ERL and System Performance for 50GBASE-CR (draft)

Presented at 802.3cd ad hoc 5/16/18.

- **This presentation is related to comment r02-15, and also investigates the effect on system performance as measured by COM of changes in ERL parameters and specifications. It builds on work presented in dudek_3cd_01_0318.**
- **No cable S parameters are available on the web site for cables with ERL close to the specification limit so Cavium CA2 was created to see what the effect would be on system performance with hosts with different ERL. The creation method and more details of this cable and the others used in the analysis are given in the back-up.**
- **Various changes to the ERL parameters have been proposed by Mellitz in comment r02-21 which will effect the values of ERL. This presentation looks at the effect of these changes on ERL.**

Cl **136** *SC* **136.9.4** *P* **226** *L* **13** # **r02-21**

Table 136–13—Transmitter and receiver ERL parameter values

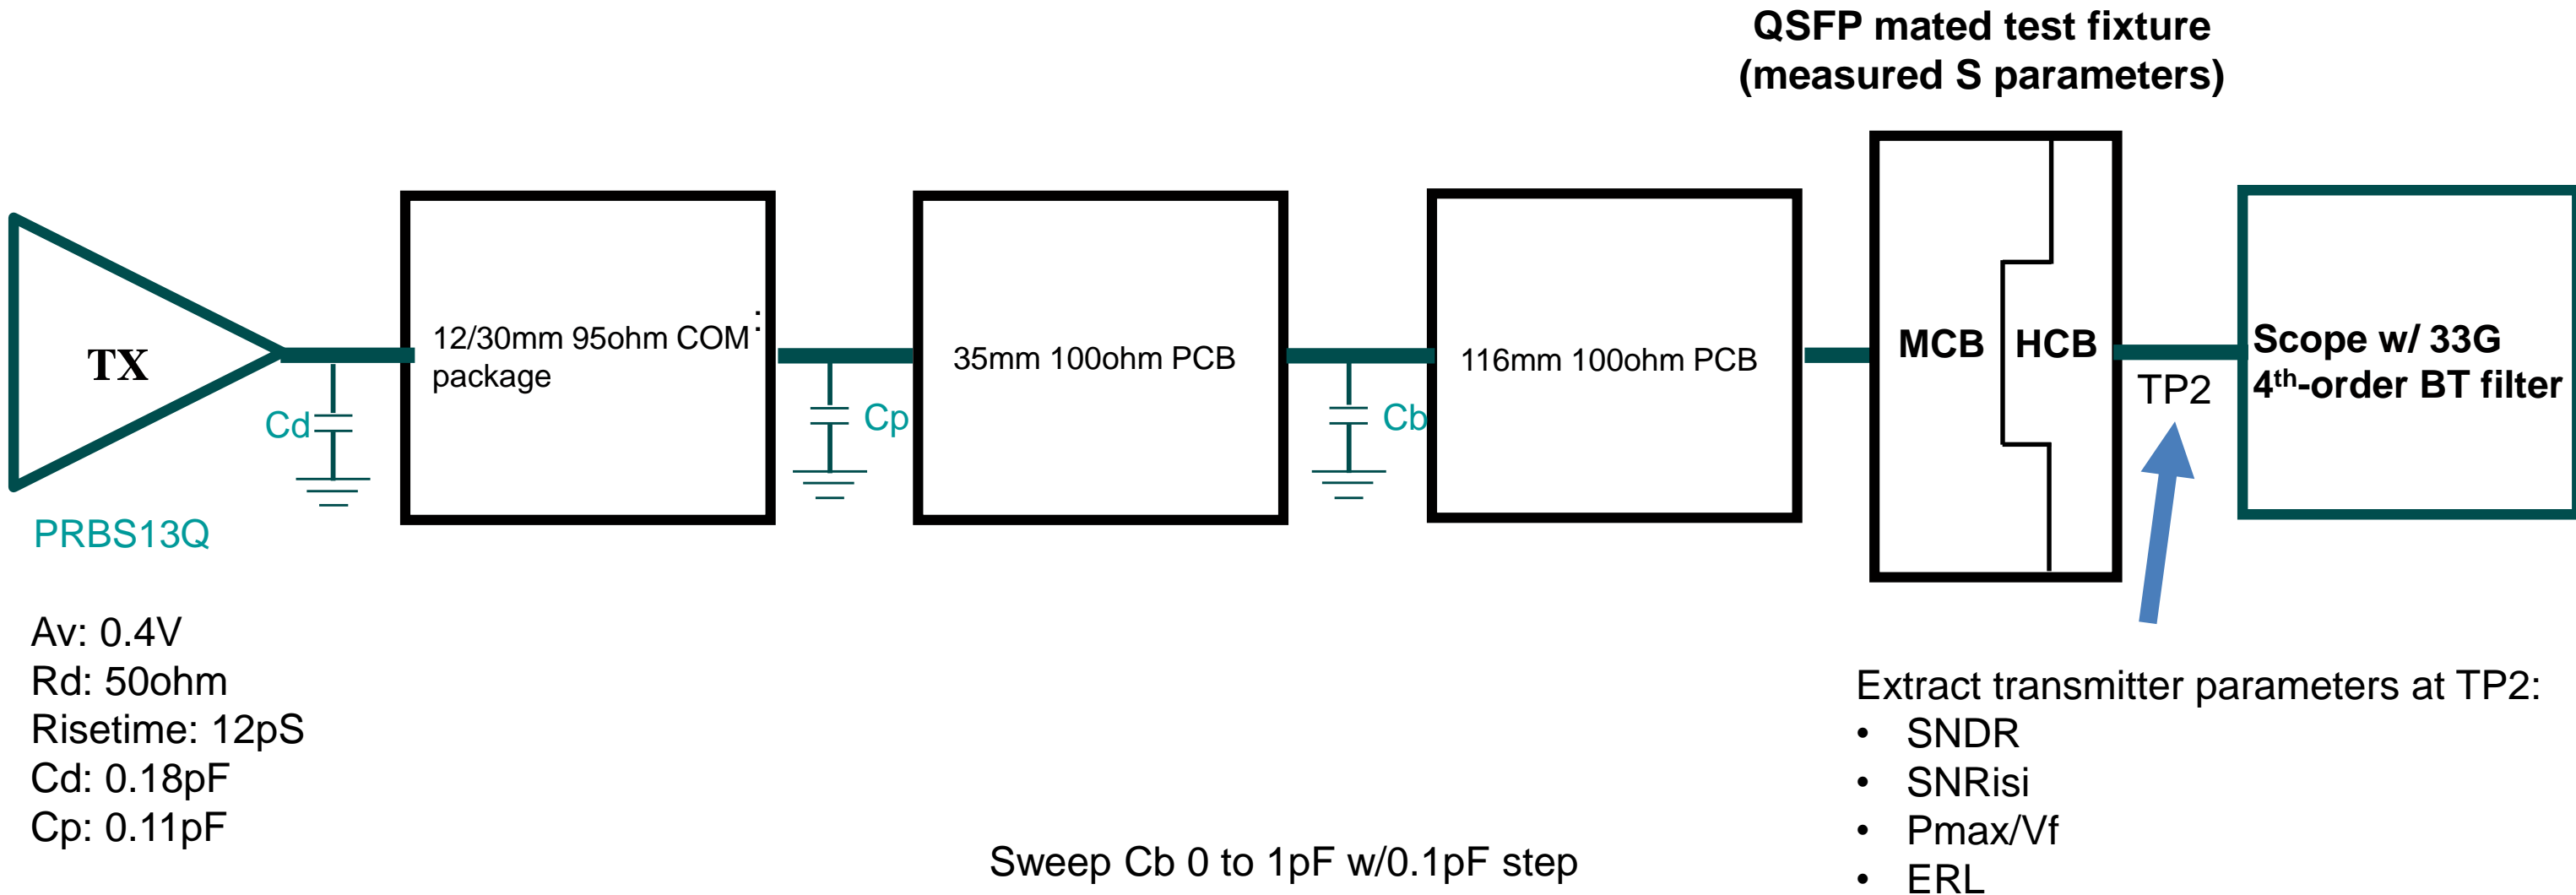
Comment

In table 136-13 page 226 change beta x to 1.7 and rho_x to 0.3

COM vs. Adjusted Host ERL (d3.2: rho=0.44 beta_x=10.7 N=300 Grr_limit=1)

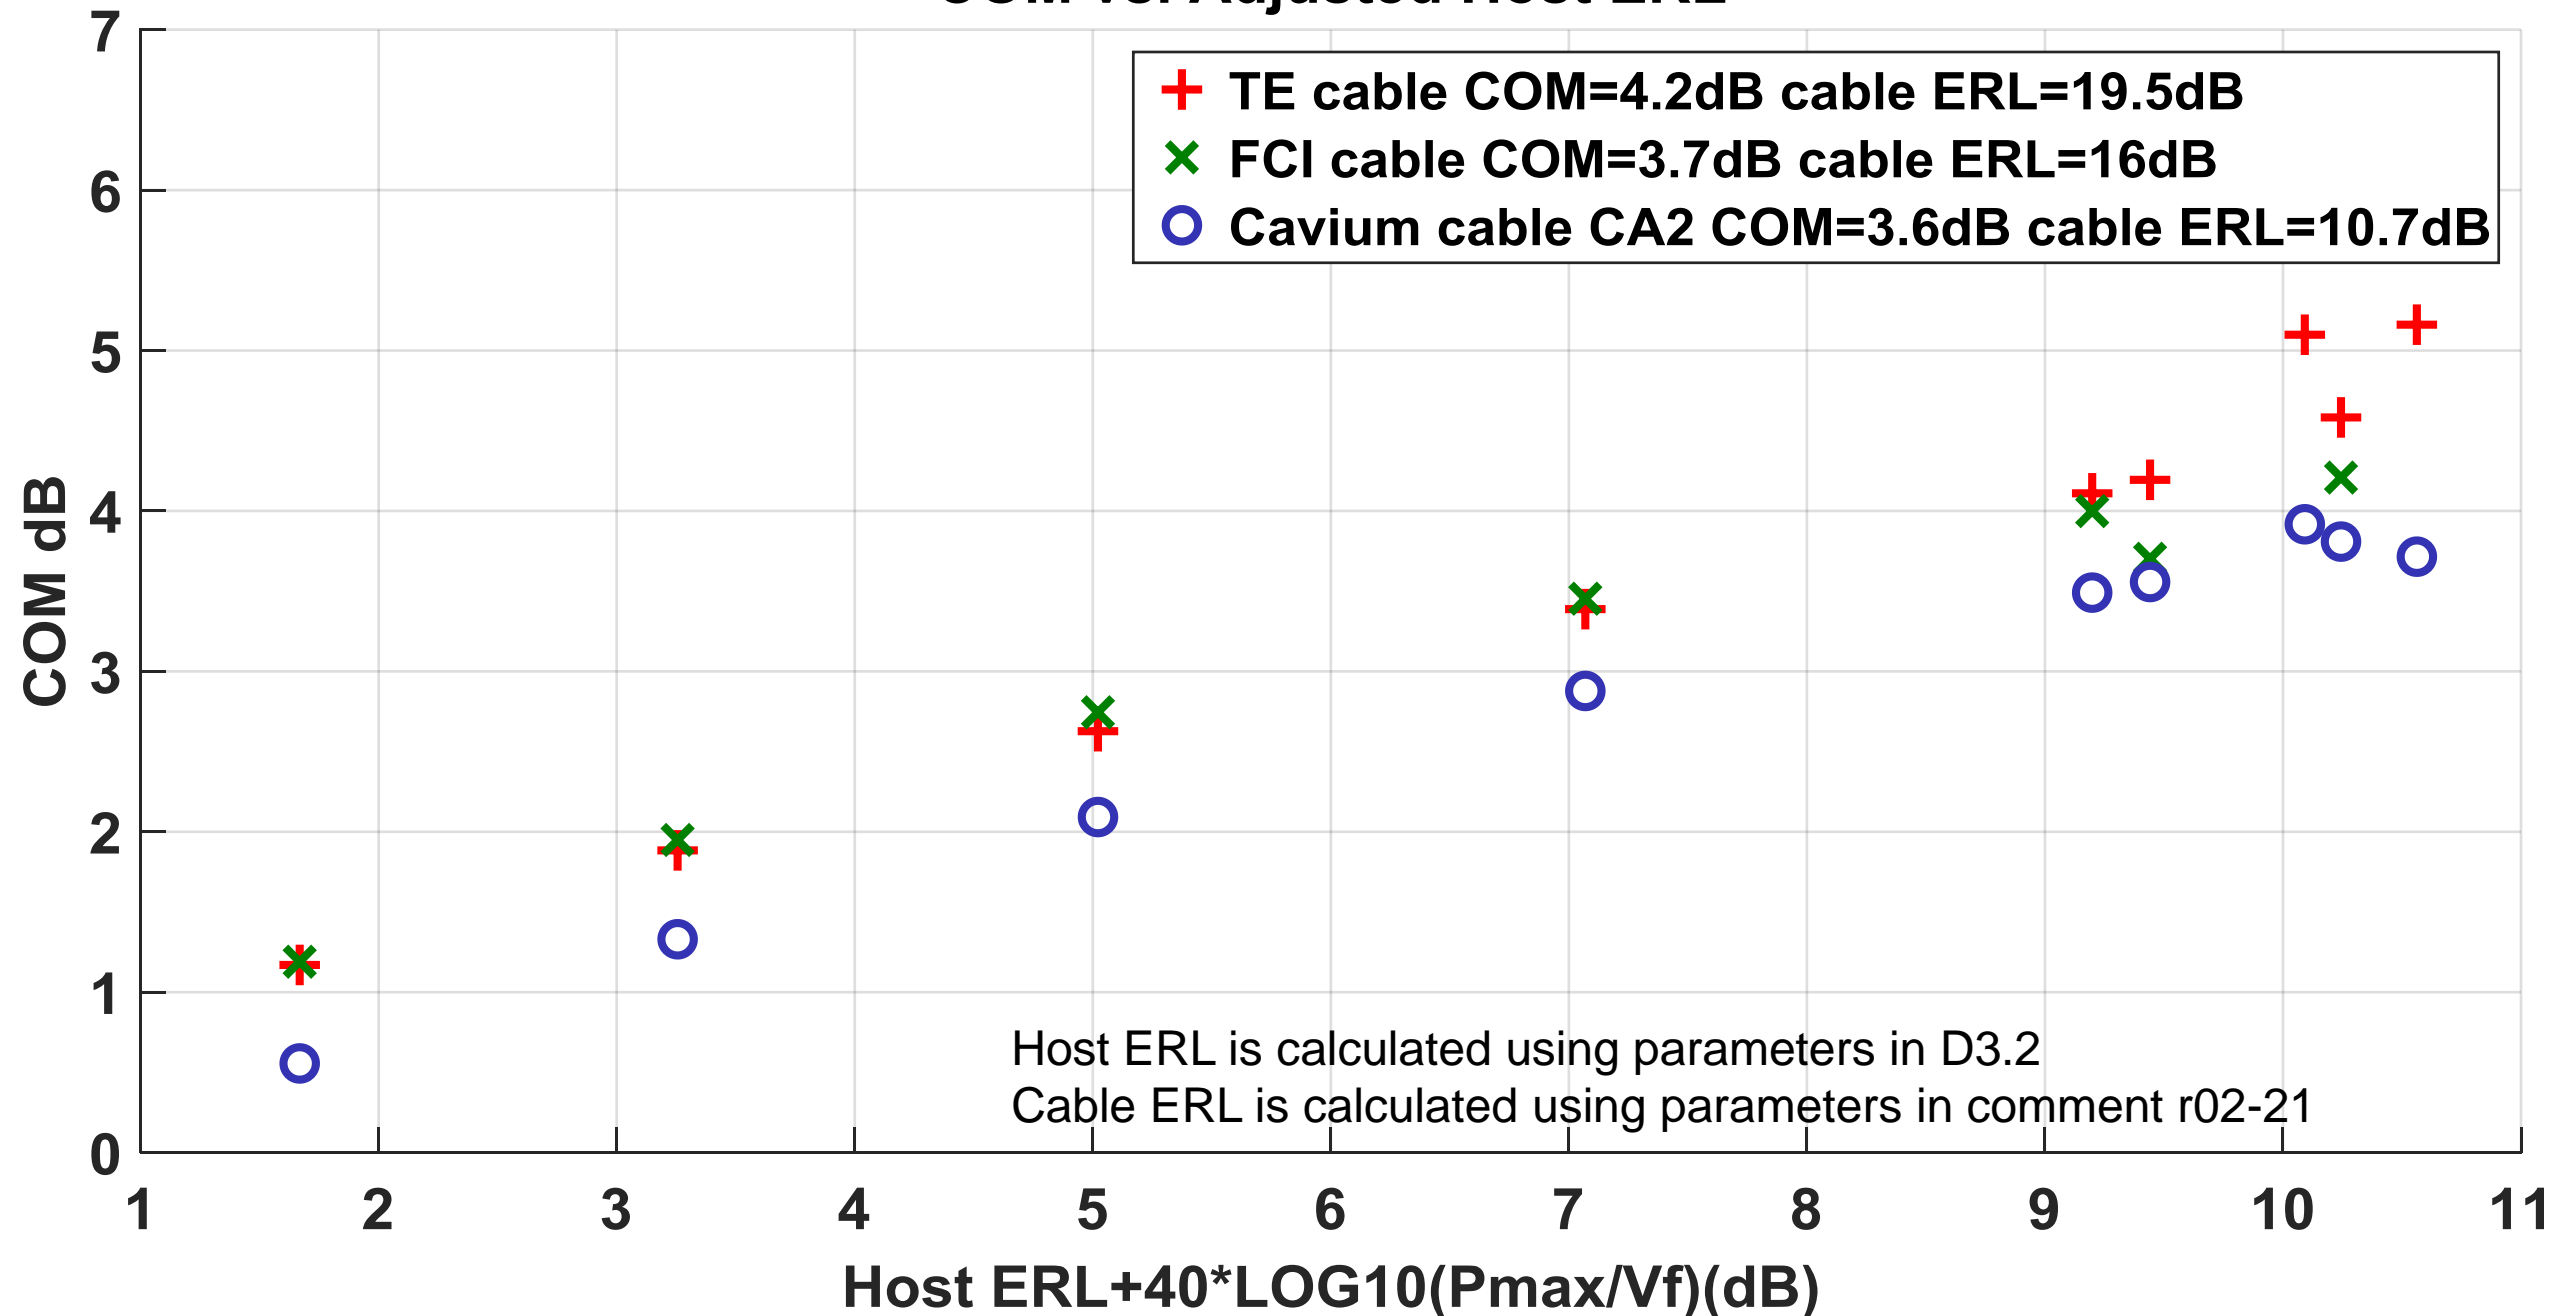
Conclusions on host Tx.

- **The proposed changes to the ERL parameters result in different ERL values (approximately 3dB lower). There are technical justifications for the changes and we recommend they are accepted but the ERL pass/fail limit needs to be adjusted.**
- **The short hosts provide good system performance on these cables and are a likely implementation. They should pass the Tx specification.**
- **The long host with the Cb capacitance at 0.3pF provides bad system performance on all these cables (and particularly CaviumCA2). It should fail the Tx specification.**
- **It has been proposed that the specification should be a single value of ERL, a single value of SNR_{Risi} or a combination of a single value of ERL plus a single value of SNR_{Risi} however no single values for these parameters exists that will not have false passes or false fails with these hosts.**

Proposal.

- **The new ERL parameters should be adopted.**
- **A specification of $ERL \geq 4dB - 40 * \text{Log}_{10}(P_{max}/V_f)$ should then be adopted.**
- **Note that it has been suggested that it is inconvenient having this combined specification as ERL is generally measured with a VNA and post processing and P_{max}/V_f is measured with an oscilloscope and post processing. With this specification however test engineering could choose to use fixed pass/fail values for the testing of their product depending on the product type with a choice of paired values. E.g.**
 - $P_{max}/V_f \geq 0.49$ $ERL \geq 16.4$
 - $P_{max}/V_f \geq 0.55$ $ERL \geq 14.4$
 - $P_{max}/V_f \geq 0.63$ $ERL \geq 12.0$

30mm and 40mm TX packages

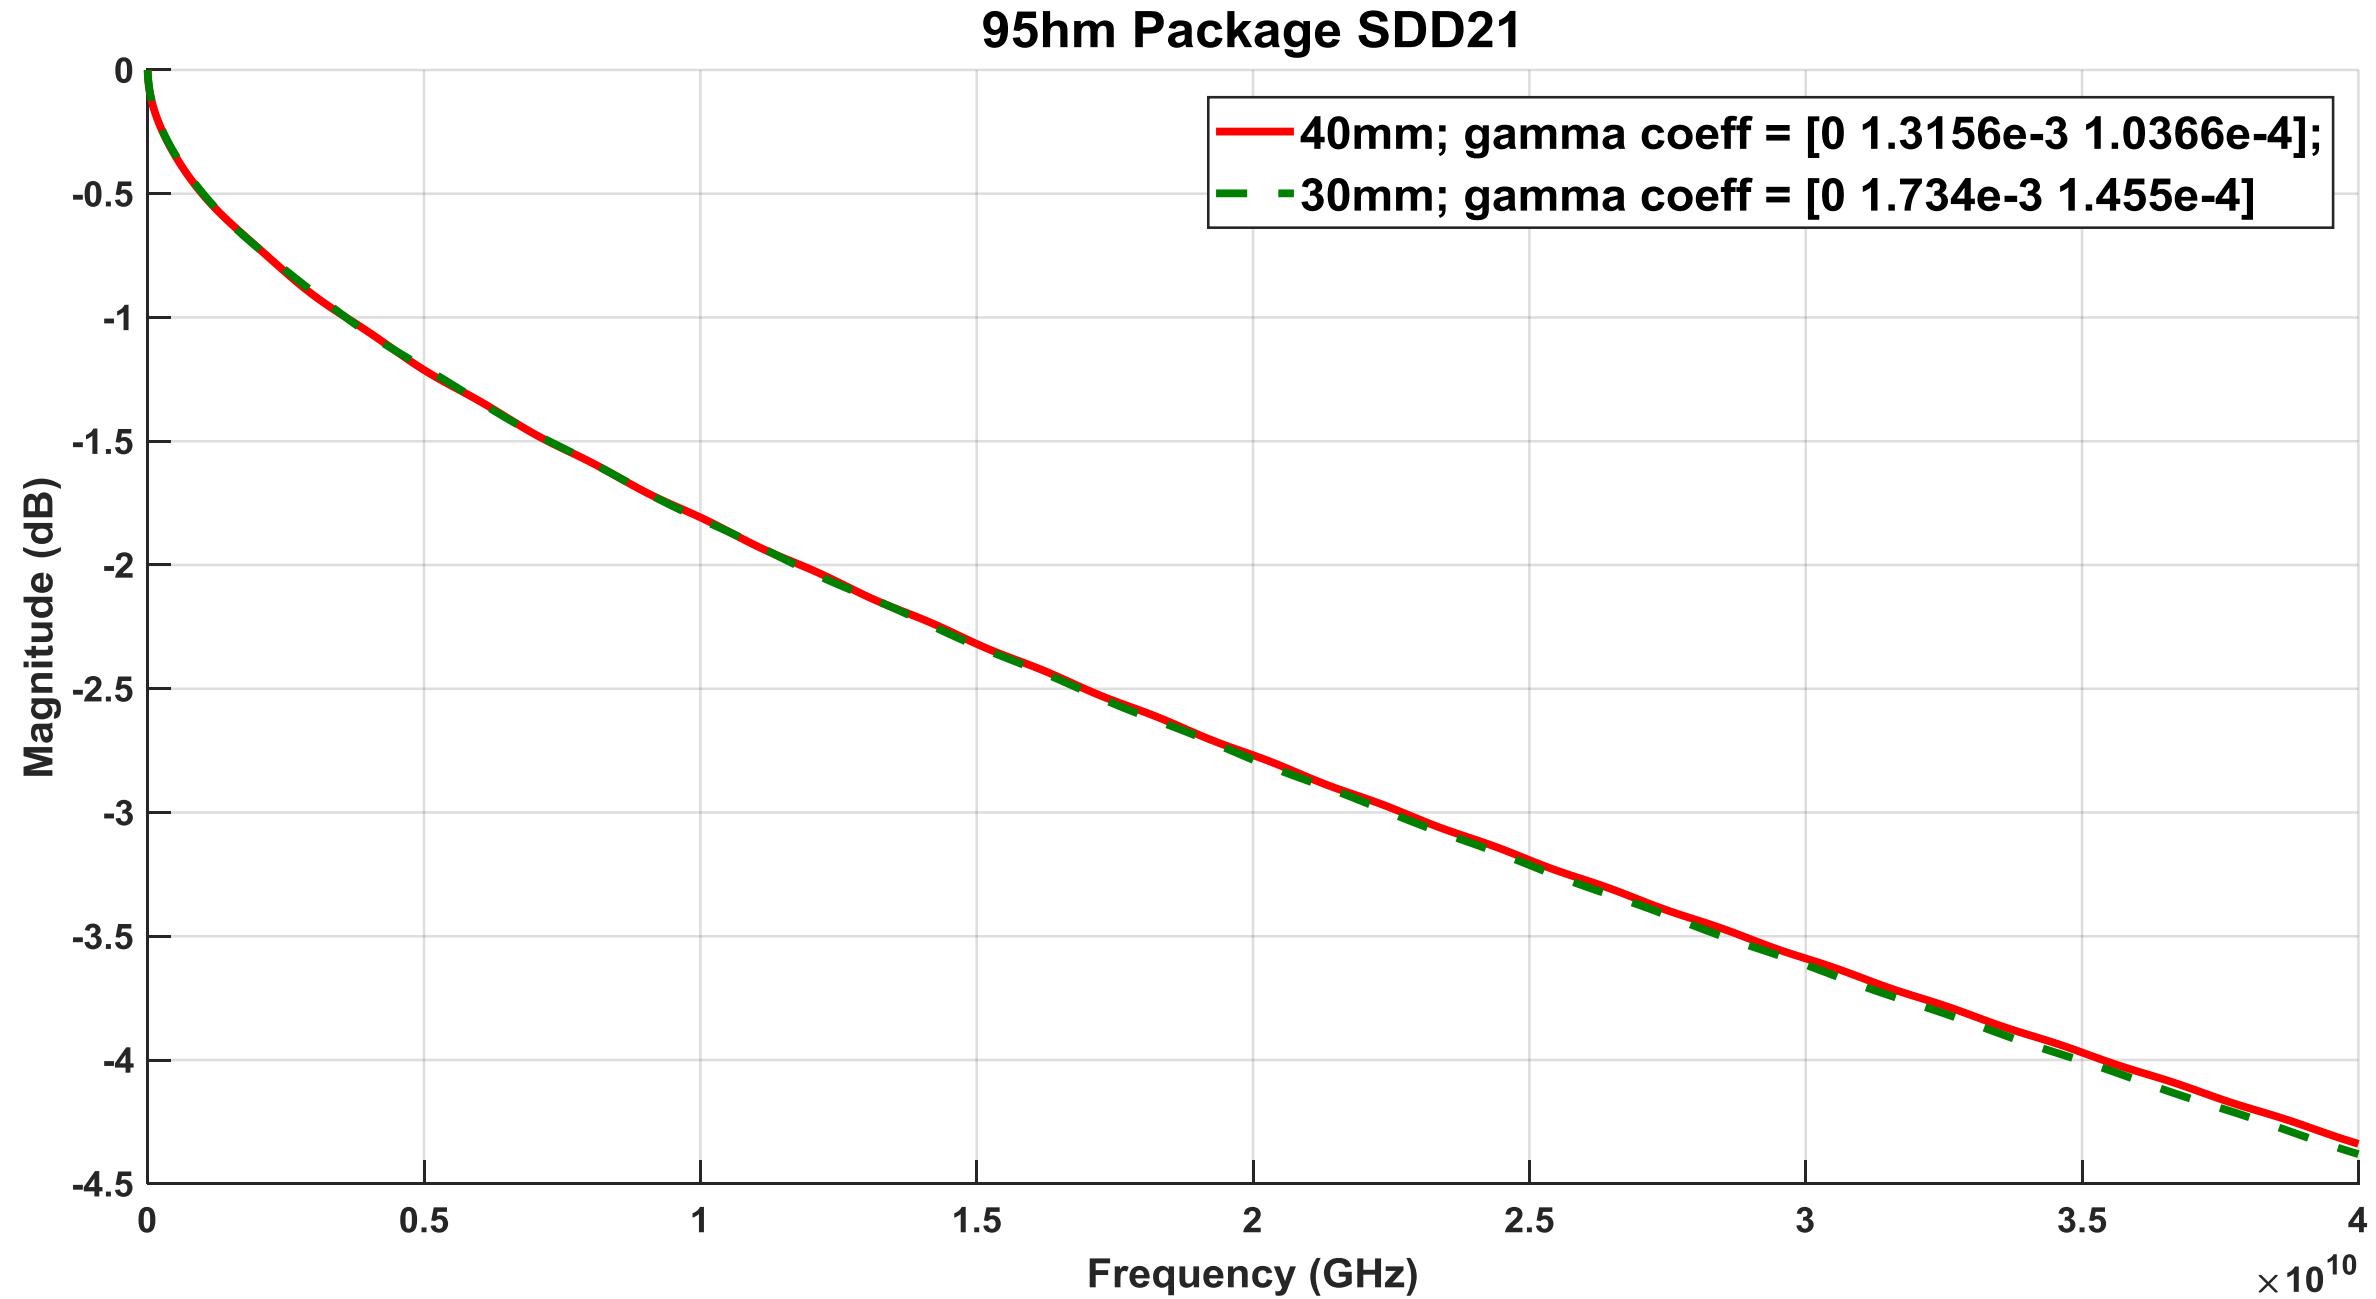
Investigation of the effect of package length on ERL and SNR_{Risi}

- **The 30mm package is the standard COM model package.**
- **The values of the parameters in the transmission line model were modified to create a 40mm package with the same insertion loss.**
- **ERL and SNR_{Risi} were measured for both packages.**

Channels	ERL D3.2	ERL Comment
pkg30mm_tp0_tp0a	19.188	21.917
pkg40mm_tp0_tp0a	15.831	15.551
